**INVITATION TO BID  
BID NUMBER 240803**

**ADDENDUM NO. 1**

Re: HIGHWAY 101, BEAVER, WA TRANSMISSION POLE REPLACEMENT

CONSTRUCTION SPEC #7

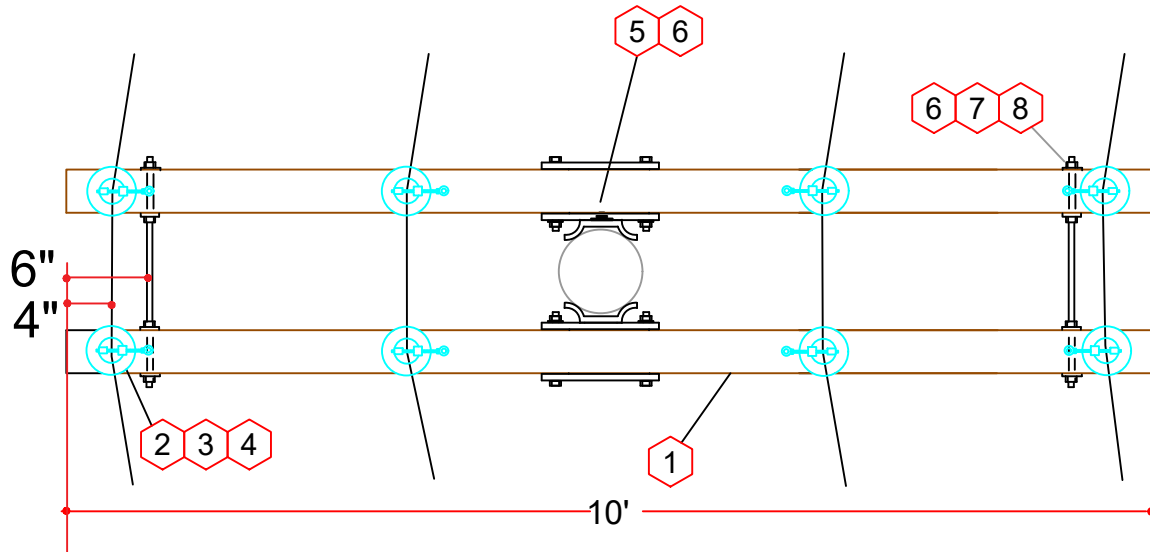
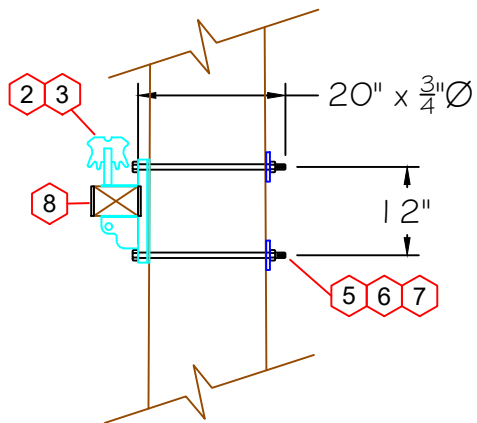
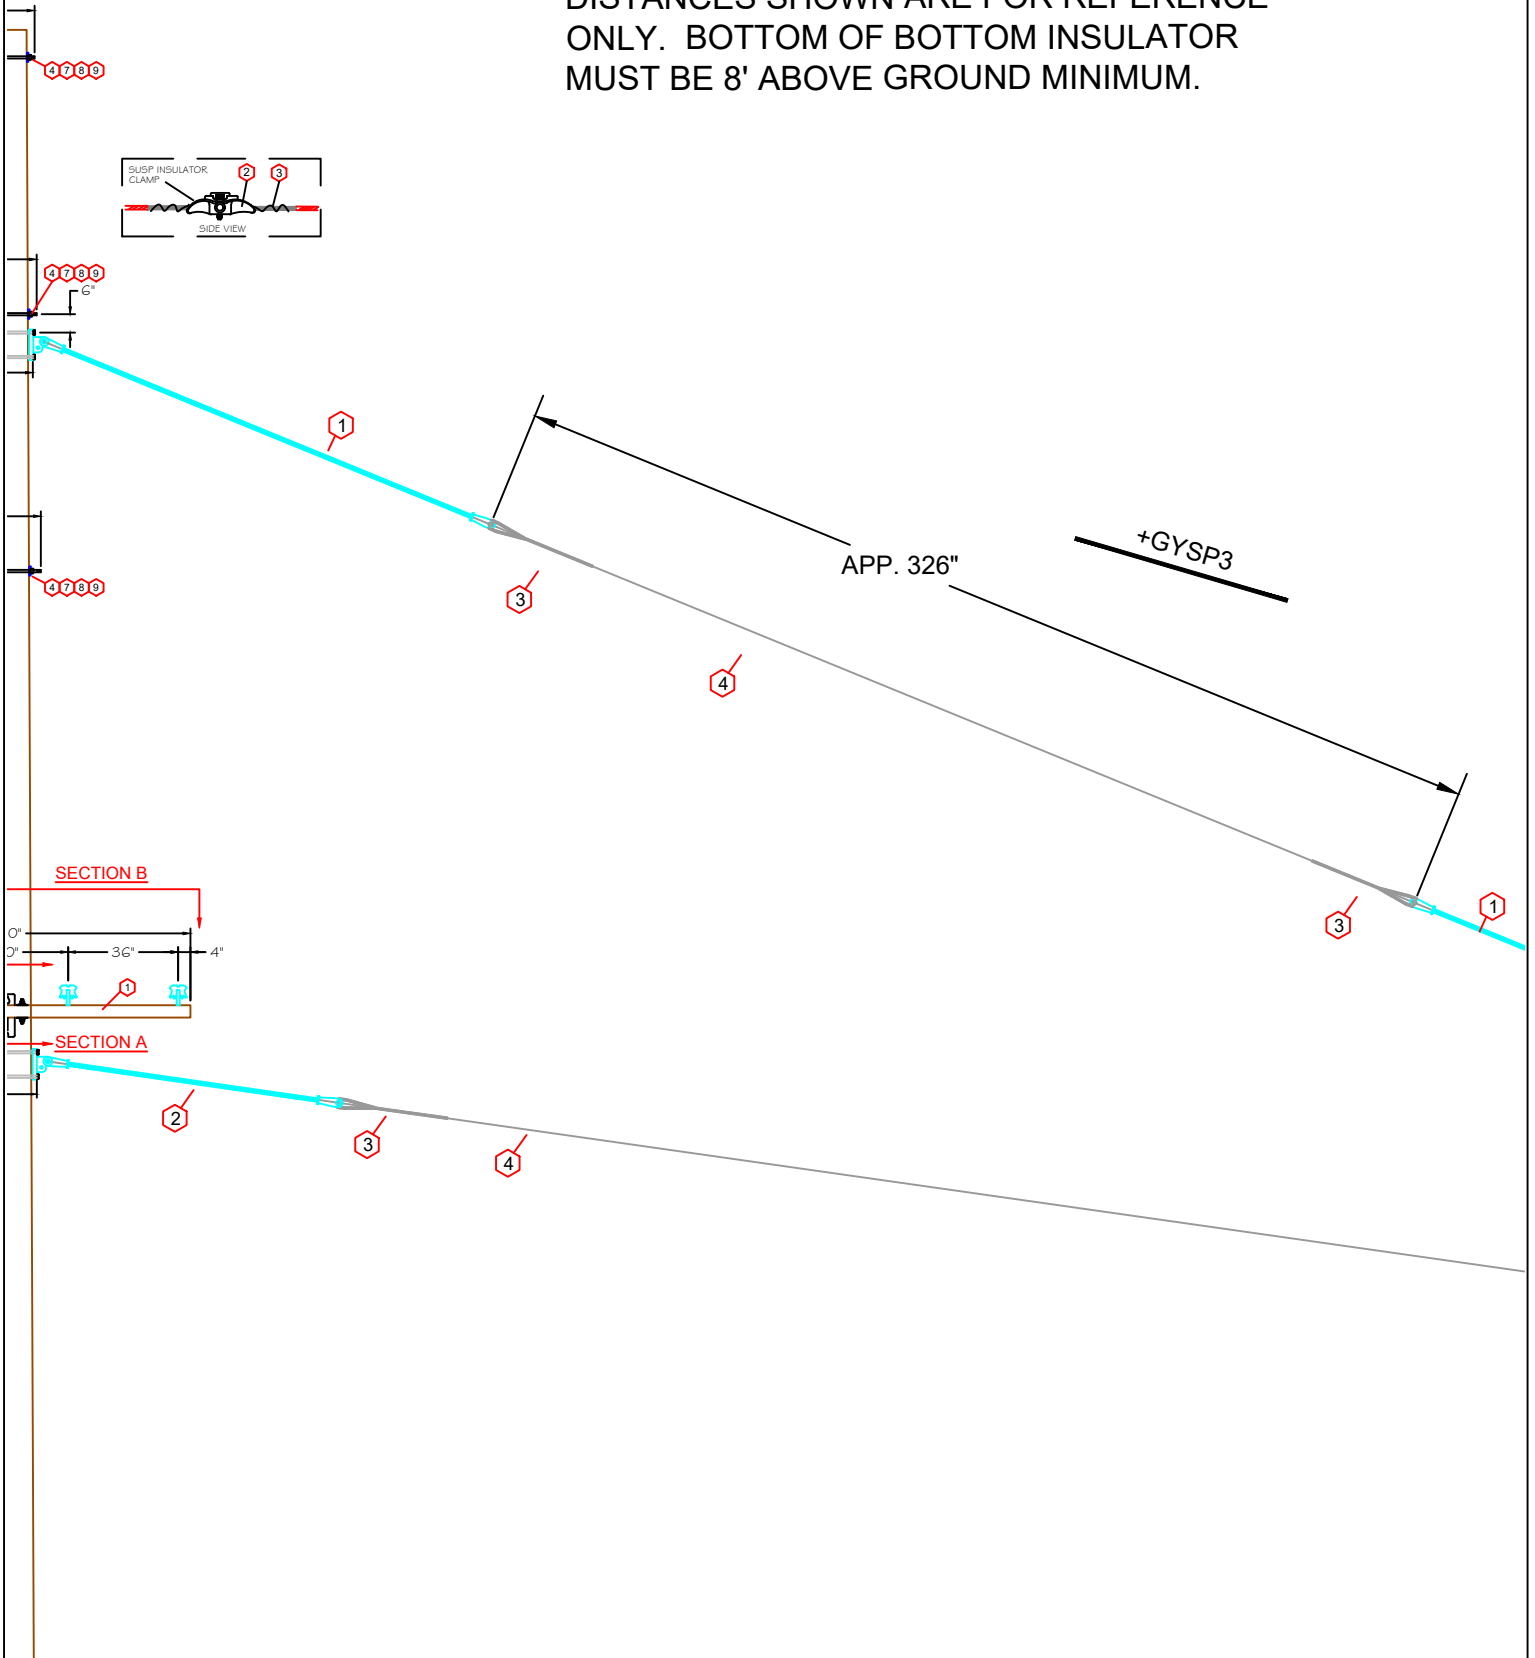
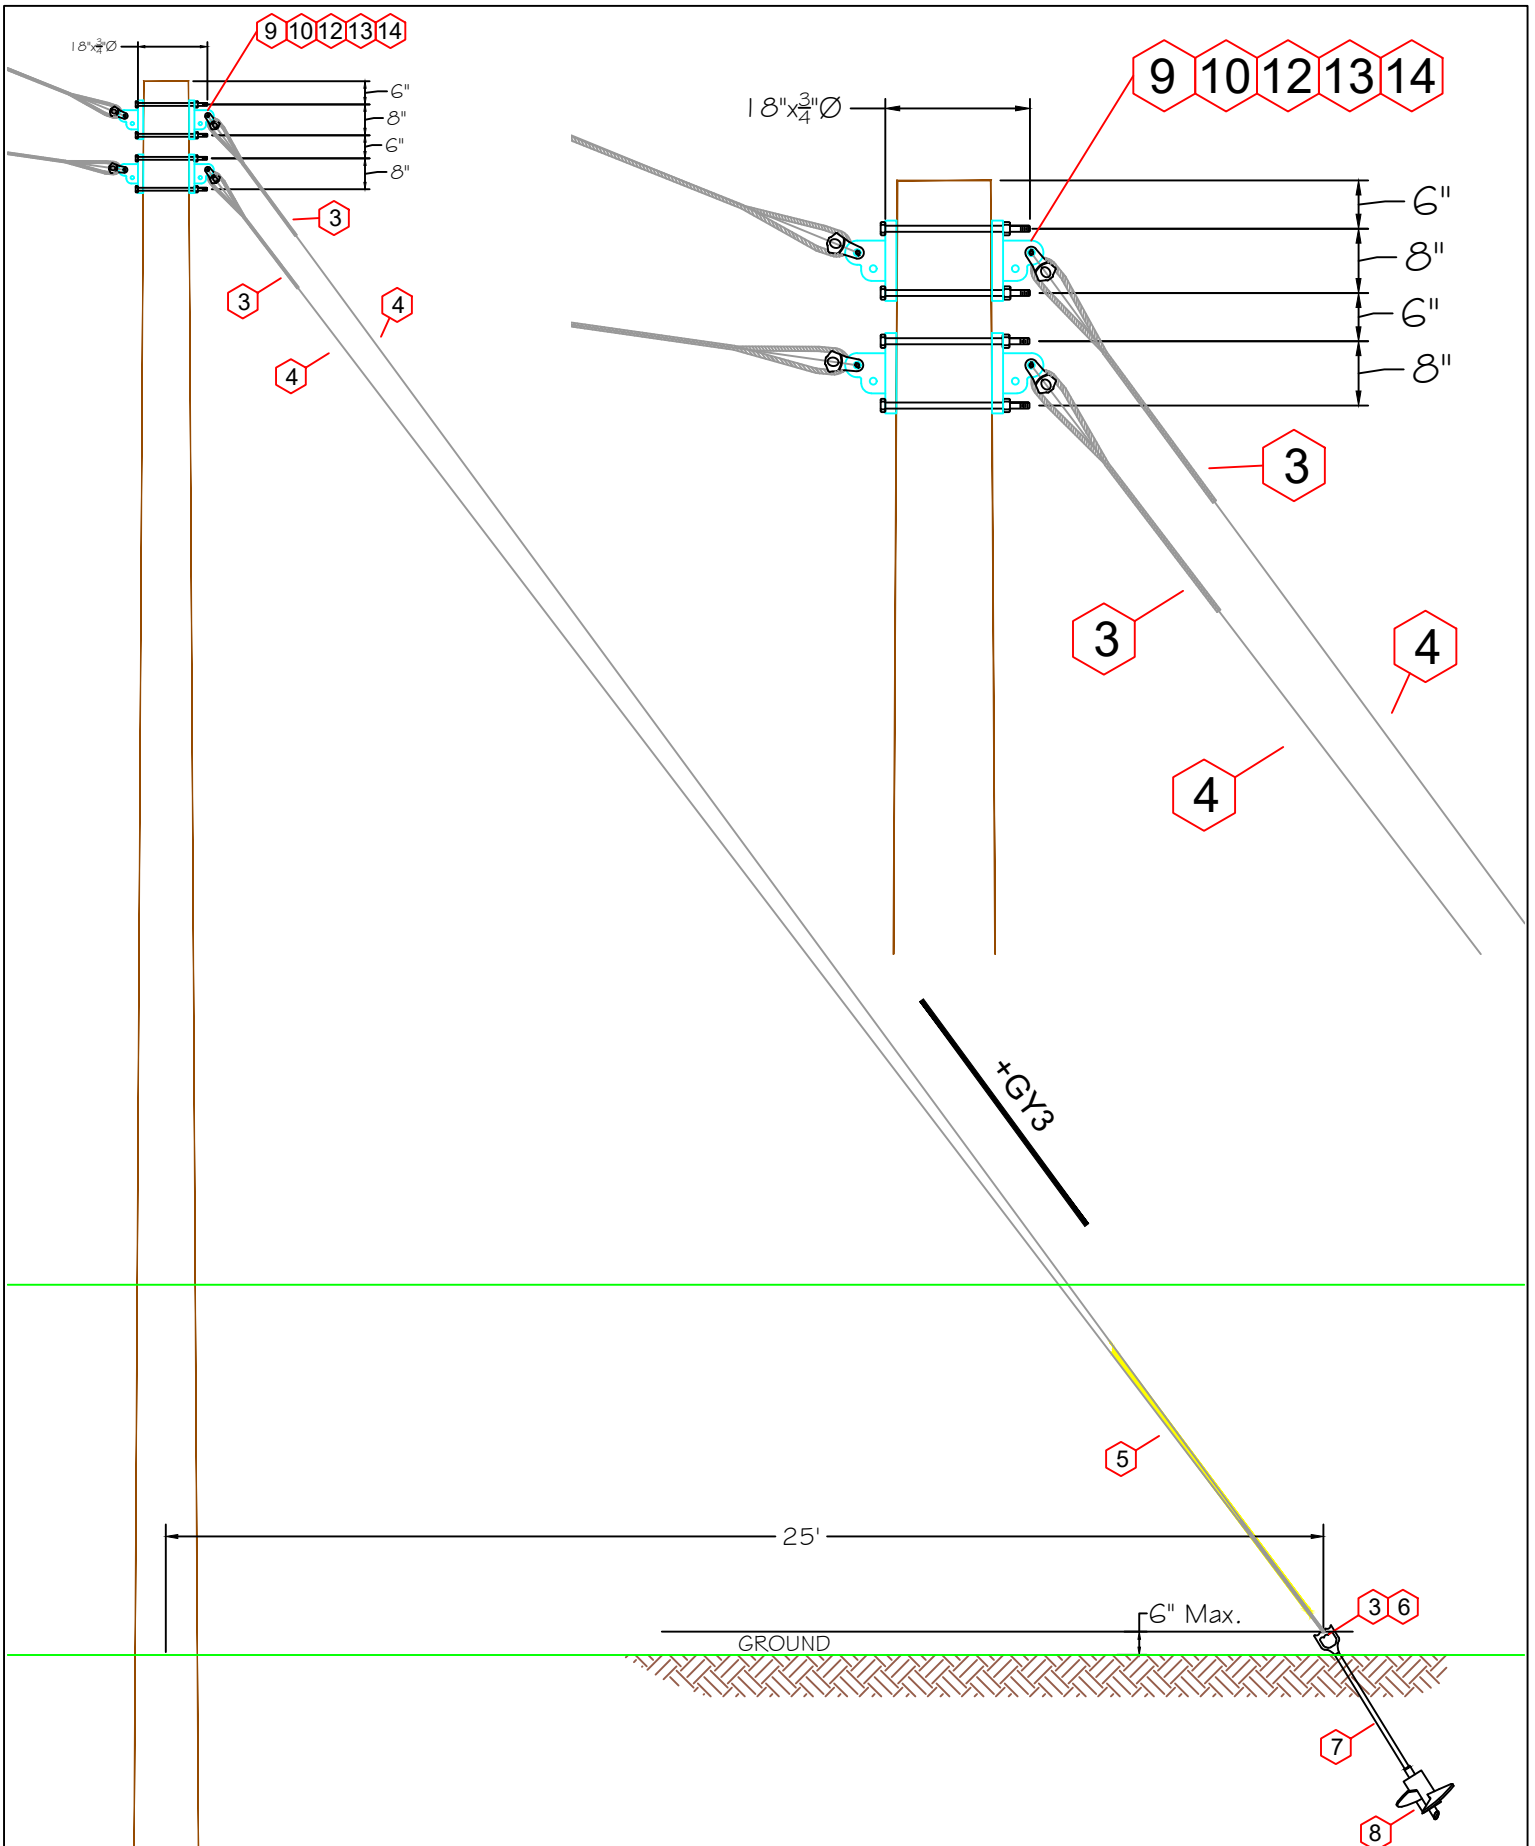
**There are only five (5) poles with foreign communications attached. Contractor will have to work with Lumen to transfer those facilities.**
- 10.) Requesting Specs for the following: GR-28, Spec #13, +GY-SP3, GY7 (Same as +GY-7?)

**Construction Specification #13 is attached and a part of Exhibit E – Construction Specifications.  
GR-28 is incorrect, please use GR-27.  
All necessary guying information is shown on the individual construction specifications.  
+GY-SP3, GY7 and +GY-7 specifications are not necessary**
